82C465MV Product Update

1 August 94

To: All OPTi 82C465MV Customers
From: Mark R. Williams, Technical Marketing Manager, (408) 486-8412
Subject: 82C465MV DMA/SMI Failure

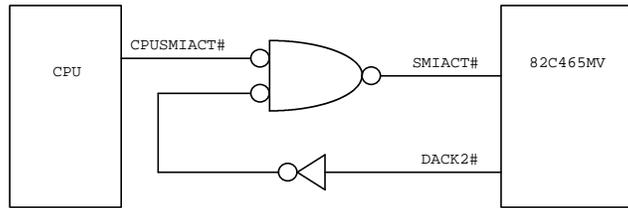
When the chipset system is operating in SMM (SMI $\text{ACT}\#$ active), a DMA transfer to or from a memory address location with the same segment as SMBASE will access SMM memory space, not the intended memory buffer in system DRAM. For DMA reads, the wrong data will be transferred to the DMA peripheral device. For DMA writes, the SMM space will be overwritten and corrupted. The 82C465MV chip fails this operation because it does not internally qualify SMI $\text{ACT}\#$ with HLDA and so always remaps SMBASE addresses to SMM memory.

For example: if a DMA write transfer to a buffer at address 3000:200h is in progress and an SMI occurs, the 82C465MV chip will go to SMM. If the SMBASE is at its default value of 3000:0h, the 82C465MV logic remaps all 3000h segment accesses to B000h because SMI $\text{ACT}\#$ is low. However, on the next DMA write transfer, SMI $\text{ACT}\#$ remains low and an access to 3000:200h arrives at B000:200h.

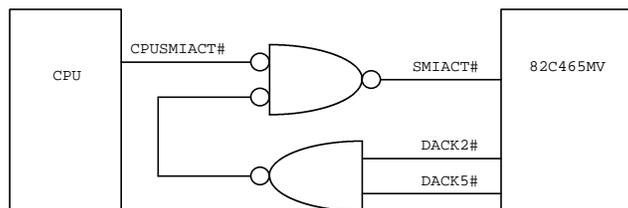
The circuit shown below handles only DMA channel 2, the most commonly used channel.

It is necessary to externally qualify SMI $\text{ACT}\#$ from the CPU with any DMA Acknowledge (DACK0-7#) signals in use from the 82C465MV chip using an OR gate. This solution prevents the 82C465MV logic from remapping the address by masking SMI $\text{ACT}\#$ during DMA transfers.

There is a drawback to this solution. The 82C465MV logic internally uses SMI $\text{ACT}\#$ to hold off further SMI# activity. When the logic sees SMI $\text{ACT}\#$ toggle, it will also toggle SMI# if any PMI events are still active and so will preset the CPU for another entry into SMM. Therefore, at the end of the current SMI service, the CPU will again be triggered into SMM. The second entry will be spurious and software will see no PMIs active, so no harm is done and no software changes are needed. The process incurs additional SMI service overhead for the extra SMI, but the extra SMI occurs only if DMA transfer has taken place during the first SMI.
